## **National Electricity Amendment (Technical Standards for Wind Generation) Rule**

**ATTACHMENT C – PROPOSED RULE CHANGES IN MARK-UP – REGA DETAILED RESPONSE.**

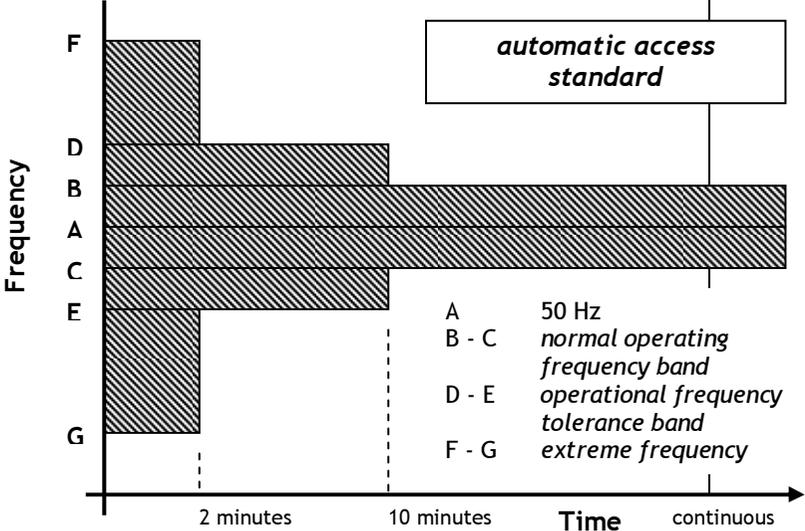
S5.2.5.1	<p><b>Reactive power capability</b></p> <p><del>For the purpose of this clause S5.2.5.1:</del></p> <p><del>'rated active power output' means the 'Rated MW (Generated)' (as defined in schedule 5.5.1) for the relevant <i>synchronous generating unit</i>; and</del></p>	<p>The definition of rated active power has been replaced to remove reference to Schedule 5.5.1, and remove technology-specific wording.</p>	<p>Agreed with comments:</p> <p>Agreed but not at any voltage level as identified in S5.2.5.1(a).</p>

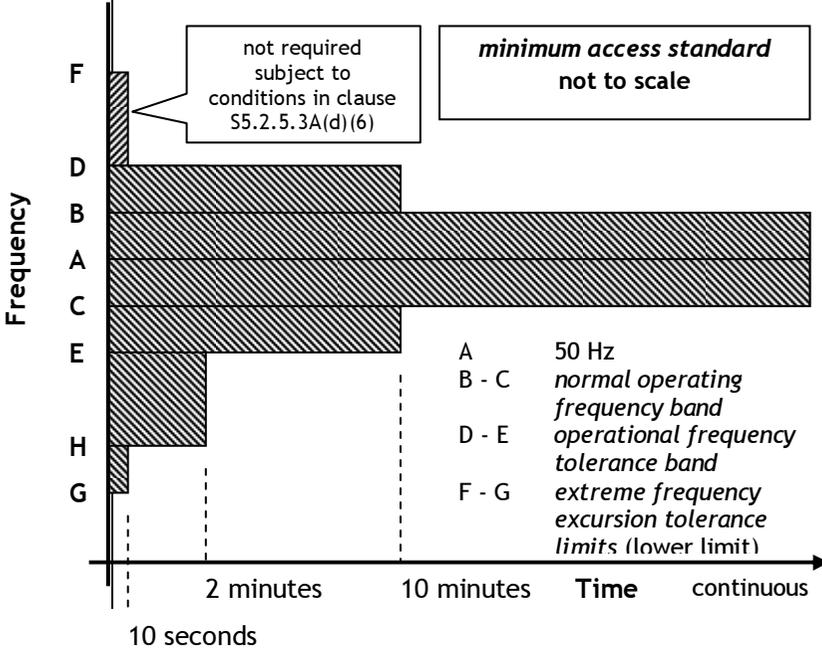
Affected clause	Clause with proposed amendments	Reason	REGA Comments
	<p><u>must be operated; and;</u></p> <p>(3) <u>may negotiate a limit that describes how the reactive power capability varies as a function of active power output <del>active power output</del> active power output due to a design characteristic of the plant.</u></p> <p>(d) <del>The Generator may reach a commercial arrangement with the Network Service Provider or a Registered Participant for the provision of reactive power capability sufficient to ensure the Generator's obligation under this clause is met.</del><u>If the proposed generating system is not capable of the level of performance established under clause S5.2.5.1(c)(1), the Network Service Provider may:</u></p> <p>(1) <u>require the Generator to pay compensation to the Network Service Provider for the provision of the deficit of reactive power (supply and absorption) from within the network;</u></p> <p>(2) <u>allow the Generator to install additional equipment connecting at the generating system's connection point or another location, to provide the deficit of reactive power (supply and absorption), which equipment is deemed to be part of the generating system;</u></p> <p>(3) <u>allow the Generator to reach a commercial arrangement with a Registered Participant to provide the deficit of reactive power (supply and absorption); or</u></p> <p>(4) <u>if the inability to meet the performance level only occurs for particular operating conditions, agree to and document as part of the access standard, operational arrangements by which the plant can achieve an agreed level of performance for those operating conditions.</u></p> <p>(e) <u>The access standard must record, the agreed value for rated active power and where relevant the method of determining the value. The value for a generating system must take into account its in-service generating</u></p>	<p>economically will be explicitly available.</p> <p>The automatic access standard has been extended to apply to any technology, and not just to synchronous plant, and to apply to generating systems.</p> <p>The basis of negotiation has been amended to clarify it, and provide flexibility in the way that reactive power is specified.</p>
